Issues:		
No.	Date:	
1	12/30/10	PLAN CHECK SUBMITTAL
1	03/17/11	FIRE DEPT. CORRECTION
2	04/17/11	PLAN CHECK CORRECTION
	Date 2	HEALTH CORRECTION

DEMO & NEW FLOOR PLAN

KULA Revolving Sushi Bar Restaurant T.I.

A-201

1 NEW FLOOR PLAN
1/4" = 1'-0"

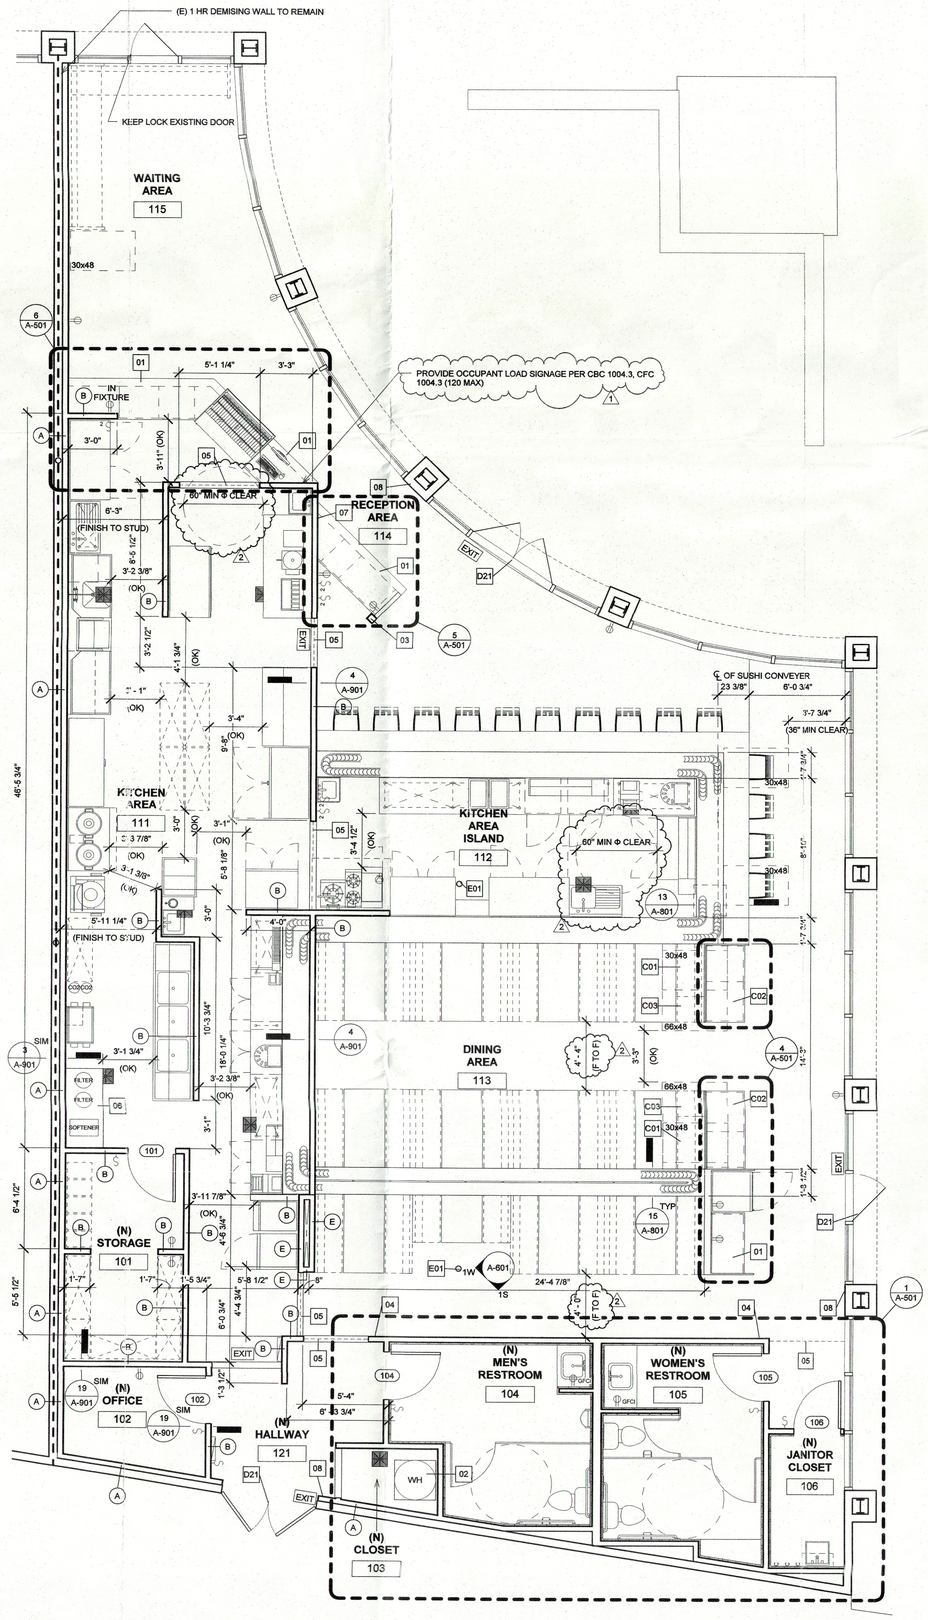
~~D11 RELOCATE EXISTING STOREFRONT BETWEEN PILASTERS IF APPLICABLE PER NEW LAYOUT. VERIFY IN FIELD~~
D12 REMOVE DECORATIVE MATERIAL ON EXISTING COLUMN 1

01 PROVIDE (N) COUNTERTOP & CASEWORK (SEE 7/A-501 FOR DETAILS 2
02 PROVIDE NEW WATER HEATER PER MECHANICAL
03 PROVIDE NEW 6"x6" (FINISH TO FINISH SIZE) FAUX COLUM BY GYPSUM BOARD OVER METAL FRAMING
04 PROVIDE RESTROOM SIGN W/ DIRECTION FOR EACH RESTROOM
05 PROVIDE REMOVABLE NOREN W/ RESTAURANT LOGO (JAPANESE STYLE FABRIC CURTAIN) TO BE COMPLY WITH CFC 807.1
06 PROVIDE PLATFORM, SEE DETAIL
07 PROVIDE OCCUPANT LOAD SIGNAGE PER CBC 1004.3 (MAX 109)
08 PROVIDE TACTILE EXIT SIGNAGE, SEE DETAIL

C01 REMOVABLE ACCESSIBLE SEAT
~~C02 MOBILE ACCESSIBLE PEDESTAL, SEE DETAIL~~ 2
C03 REMOVABLE SEAT

SEE COVE BASE TILE DETAILS
*PROPOSED HIGHEST CEILING HEIGHT IS 11'-0" AFF, SO APPROXIMATELY MAXIMUM STUD HEIGHT IS NOT MORE THAN 12'-0" 2
